| A) Design Calculation Number <i>DC-5882</i> | | B) Volume Number <i>Vol. I</i> |
| J) Title <i>Verification of Turbine Building East side Overhead</i> | | |

TSR- 26565

A) Title (Subject): TURBINE BEARING BEAM REPAIRS

DEC. FILE NO. T1-637 PAGE 1 OF 2

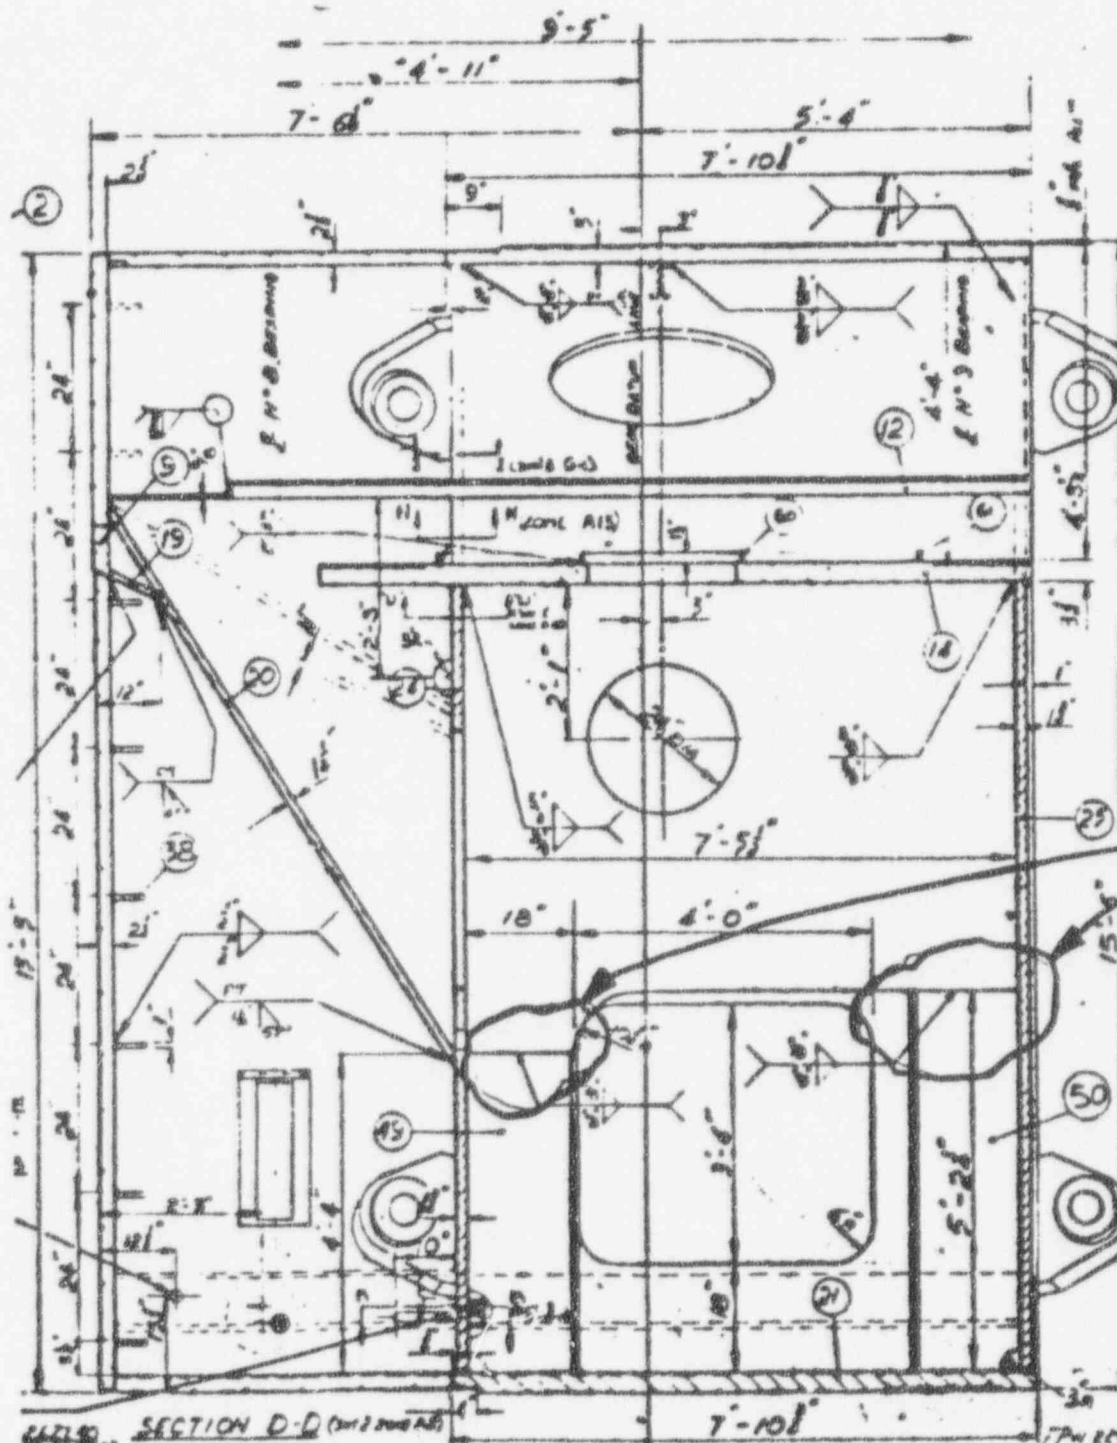
DOCUMENT TO BE REVISED

SEE
TSR-2656
FOR DETAIL:
Pg 16, 17 & 18

DTC: DDVEND DSN: R205A1929 REV. J
 DE.CO. FILE NO. TI-642 PAGE 3 OF 3
 ZONE: C 10

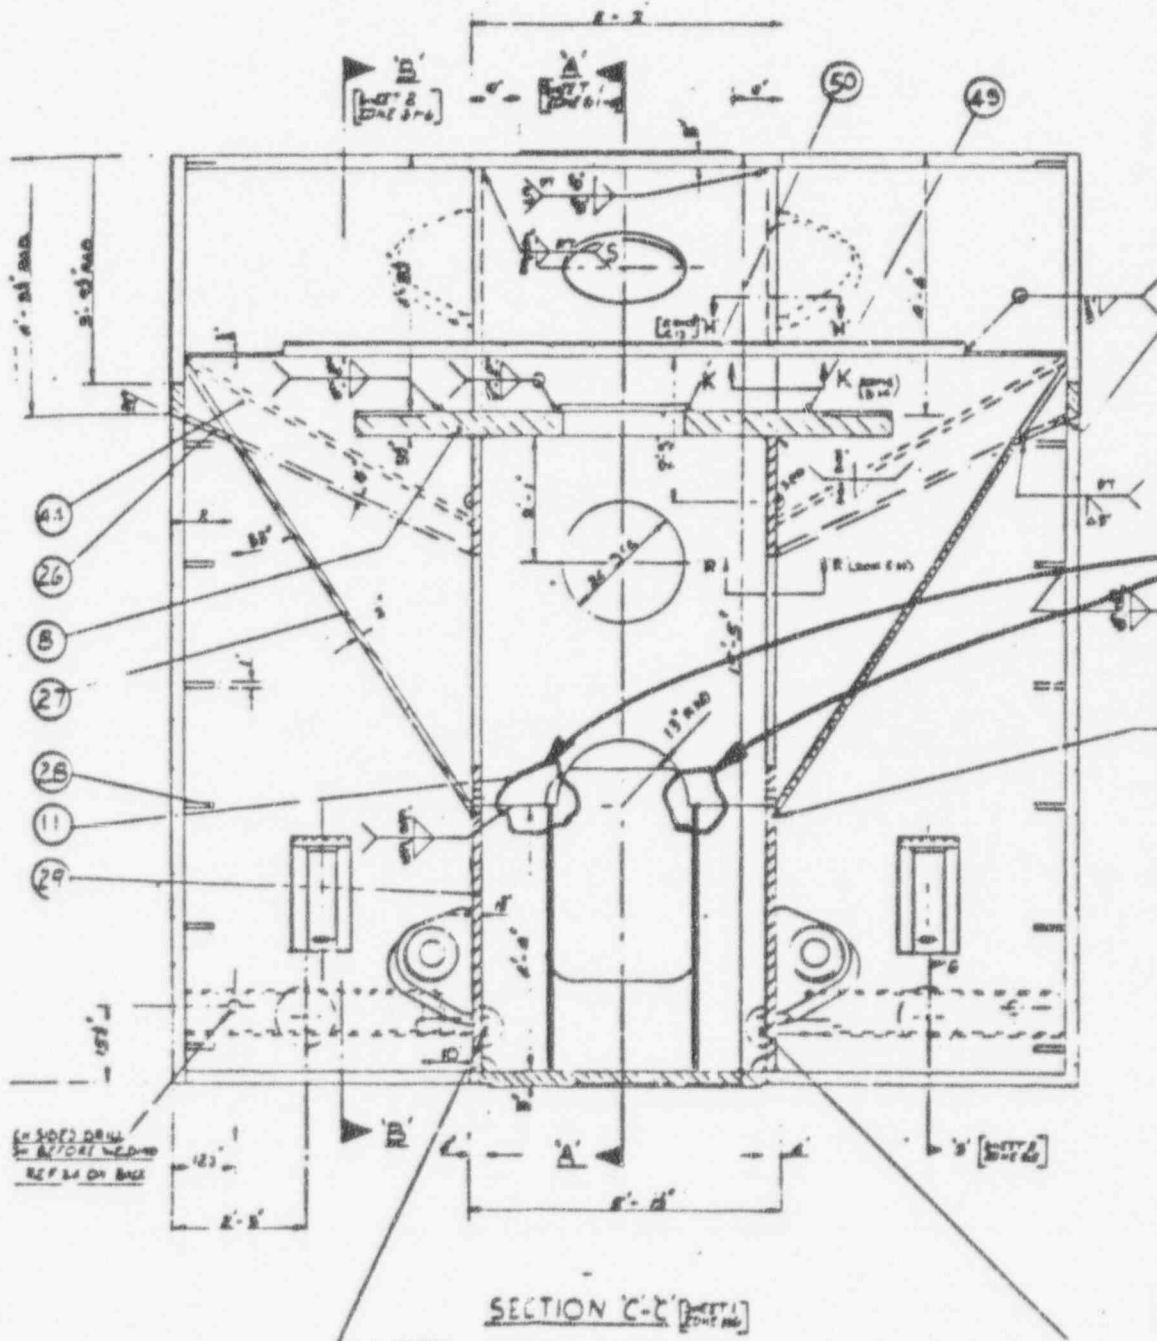
DOCUMENT TO BE REVISED

FOR DETAILS
 SEE
 TSR-2656
 R. 19620

FIGURE 2 - Cavity Configuration on T-web Base Metal

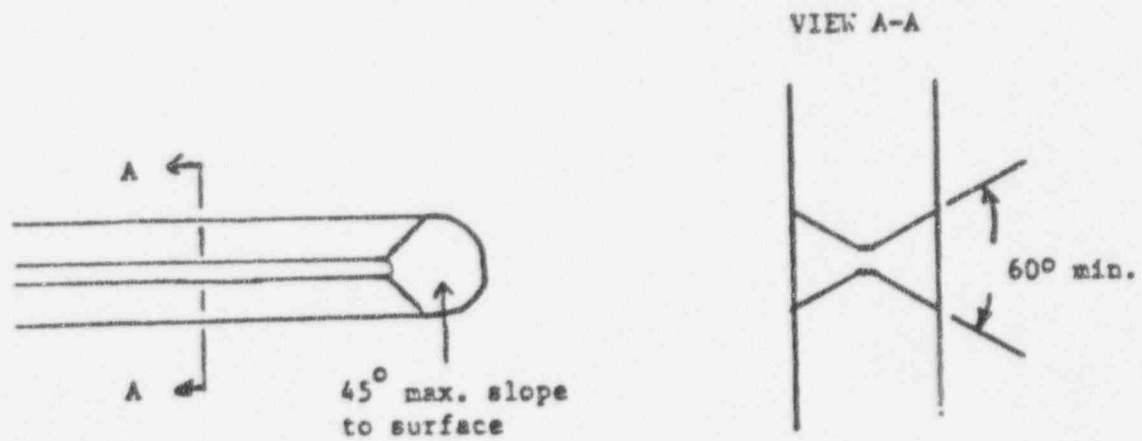
Remove the cracks by grinding. Prepare a double V groove. See Attachment 4 - Sketches, Figure 2, View A-A. If the other side of the base metal is not accessible, such as the vertical plate nearest generator, the base metal should be ground out to a single V-groove, similar to Figure 2 as described above. A ramp, or slope of 45° maximum should be provided at the ends of cavity. If needed, a backing plate may be used. The complete base metal crack removal shall be verified by magnetic particle testing (MT)

Bearing Beam #5 (Generator End) Reinforcement Details:

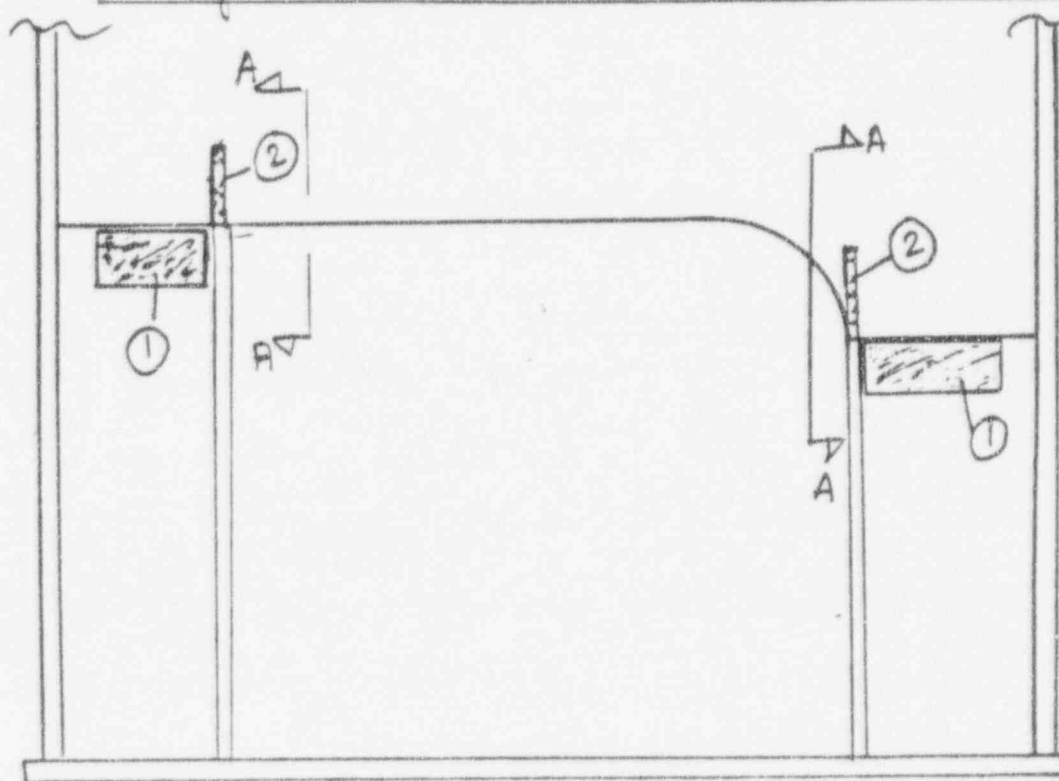
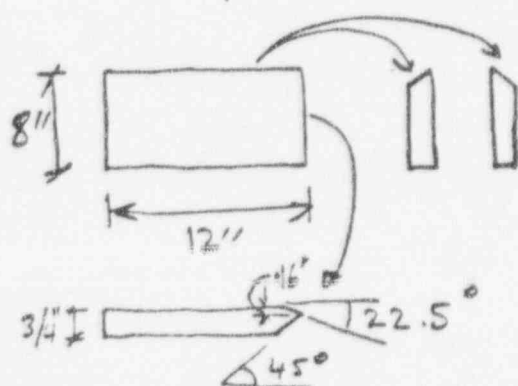
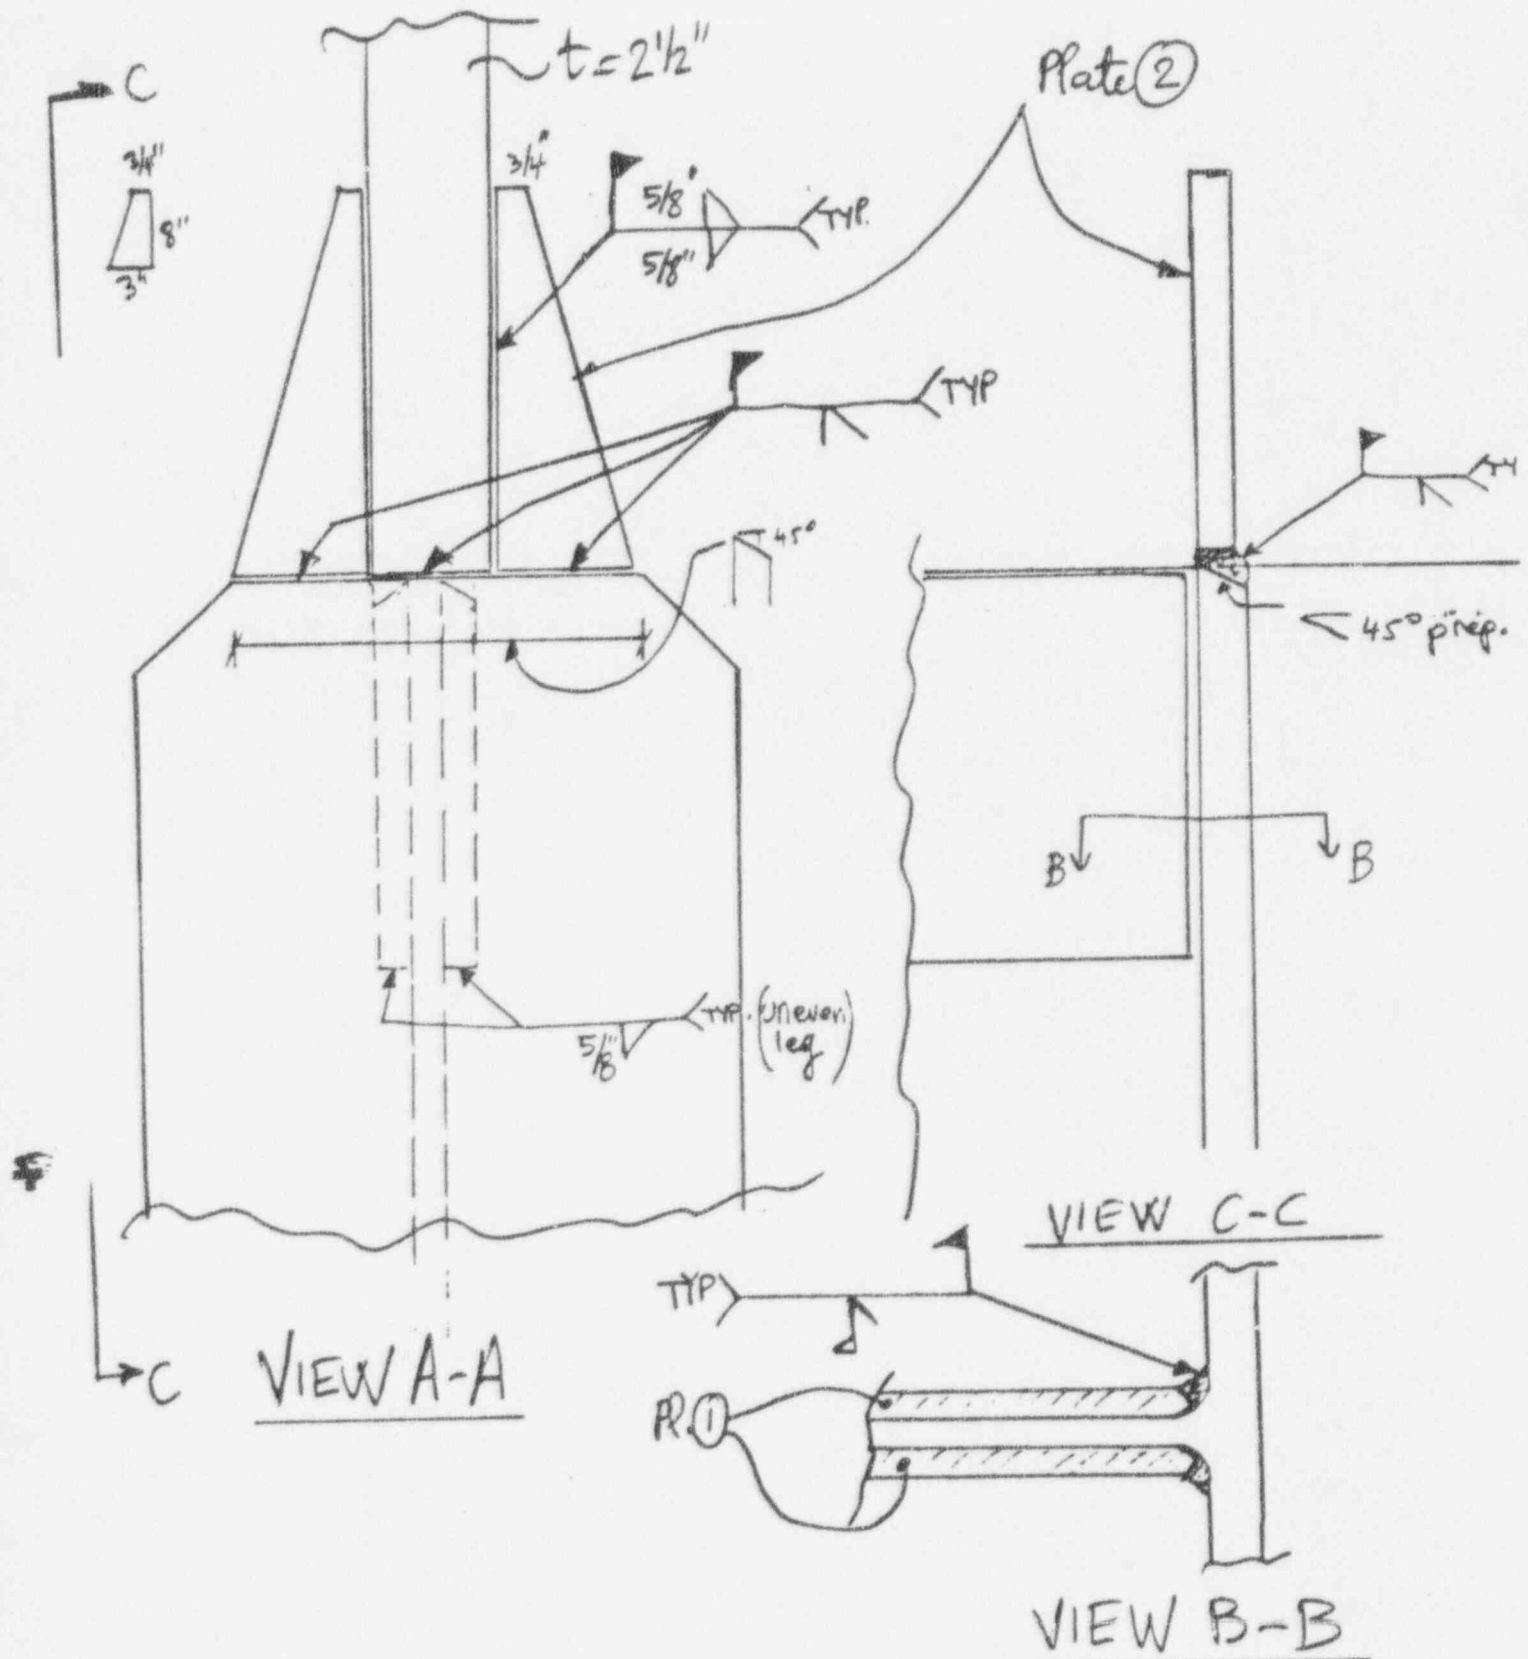
Apart from the repair of cracks, a weld design change will be made during the repair. This weld design change will eliminate the wrap around welds between T section and 2 1/2" thick rib plates. The walkdown data indicates that this weld was completed as a fillet weld and indications point to this location as the starting point of the propagating cracks. This design change will be repeated at four locations per bearing beam, in total of 16 places. The revised drawings in this TSR reflect these weld changes. Reinforcement plates used in this repair process are detailed in Rev. A of this TSR. A

Plate (1) - $3/4"$ thick $8" \times 12"$ ROS# C046144Plate (2) - $3/4"$ thick $3" \times 8"$ ROS# C046144

8 of each required for #5 bearing beam.

Reinforcing & Repair Details For Bearing Beam #3
Ref. T1-637

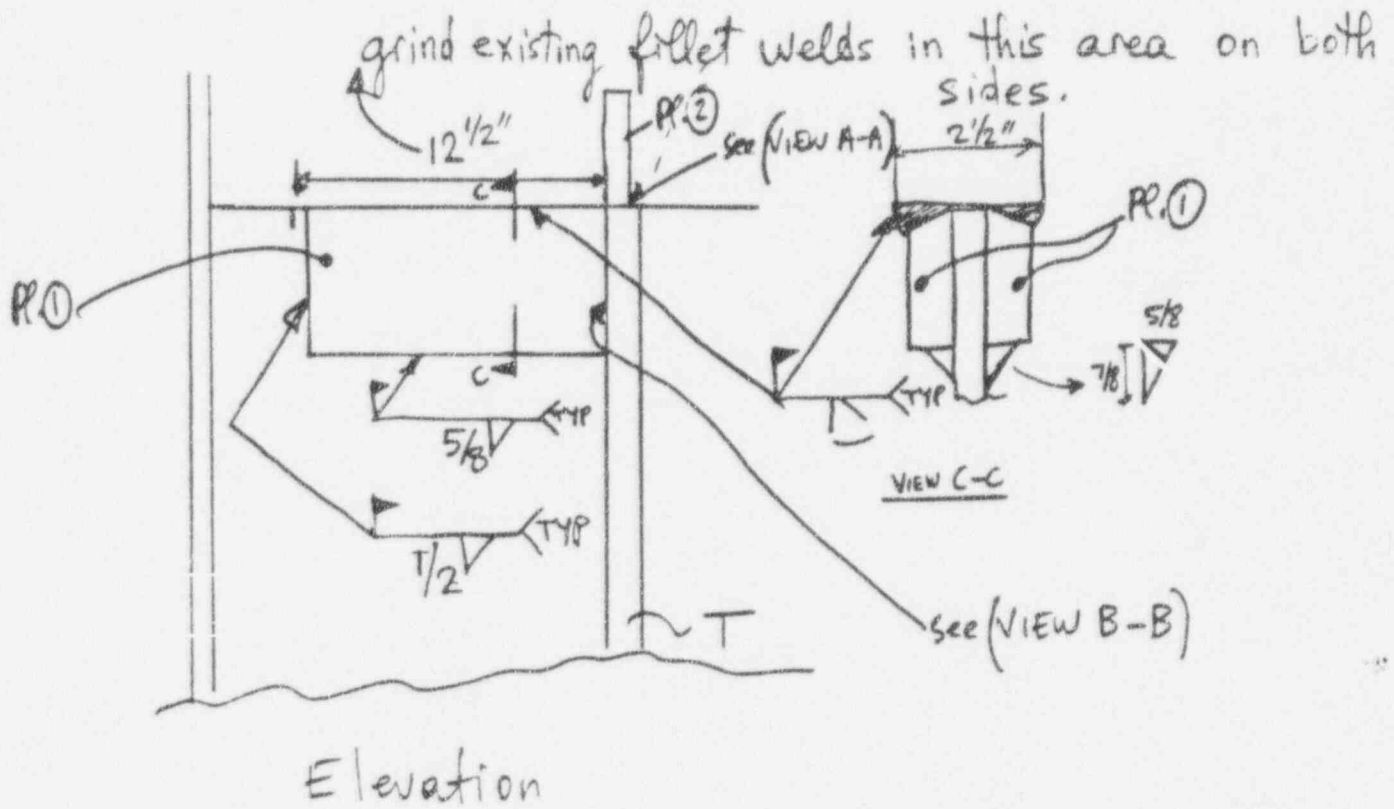
This TSR modification is prepared for the repair of cracks found in the bearing beams, as described in DECo File No. T1-3686. Additional reinforcement was also performed as described in this Rev. A of TSR-26565. A
